Lardner's Point Pumping Station Replacement/Rehabilitation

Contract A - Sewer Maintenance Facilities

Application for Art Commission Construction Approval (Final)

Contract A – Sewer Maintenance Facility at NEWPCP Philadelphia Art Commission Construction Review Final Review Presentation

New Construction v4 Checklist (Draft)

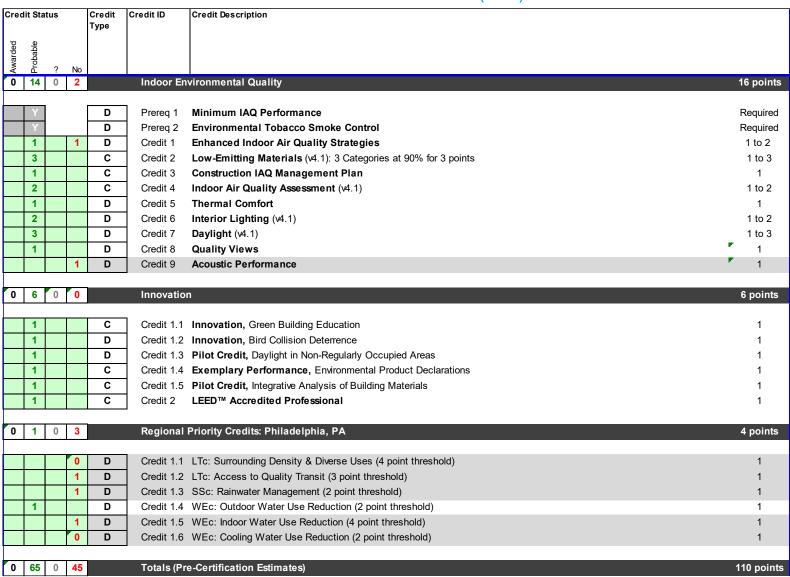
• Provide more details on LEED certification goals, including related site assessment work; consideration of concrete mixes with cement substitutes; and consideration of dark sky compliant lighting, ideally 3000K or less.

- Project using the LEED "New Construction v4 Checklist".
- City of Philadelphia Bill No. 080025 requires LEED Silver Certification. Current project checklist estimates LEED Silver Certification with potential for LEED Gold Certification.

- Performed Phase I Environmental Site Assessment in 2025. Final report to be completed in 2025.
- Design specifications require 40% slag cement and/or fly ash to replace portland cement in order to reduce embodied carbon.

- Design calculations demonstrate recycled content in concrete and lighter façade materials (e.g. insulated metal panels) result in a 16% reduction in embodied carbon compared to a baseline building.

- Exterior lighting fixtures selected for dark sky compliance.
- Design calculations demonstrate little to no uplighting. Majority of exterior fixtures have an uplight rating of U0 and one fixture has an uplight rating of U1.

- Exterior lighting fixtures are consistently specified at 3000K.

LPPS Site Plan

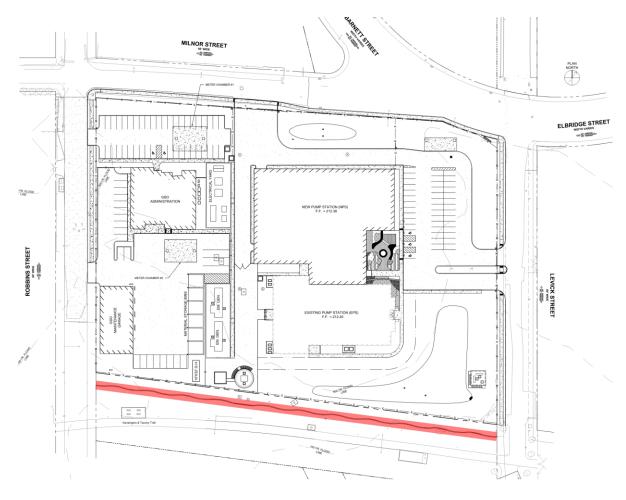
Thank you for this thorough overview and summary, and please accept my sincere apologies for the delayed response. Creative Philadelphia agrees with the proposed approach for Lardners' Point Percent for Art consisting of the following:

- 1) Aggregating the Percent for Art funds from the two sites (approx. \$3.6M TBD) to locate artwork on the LPPS site only.
- 2) Identifying the public art as a custom artist designed, metal site wall/fence that will be located along the K&T trail.

However please note as standard practice we would not mandate the fence to be a certain shape (such as curved as you have listed), unless we had to for site reasons. So it may or may not match the outline shown on your sketch. We will work with your team to ensure that the allowable site parameters are clear to all competing artists in terms of site constraints, but would not want to limit the creative possibilities.

- Per email dated January 17, 2025, Creative Philadelphia in agreement with the following approach to incorporate Percent for Art requirements into the project:
 - Aggregating public art funds from the NEWPCP and LPPS sites and locating all public art on the LPPS site.
 - Identifying public art as a metal site wall/fence located along the K&T Trail.
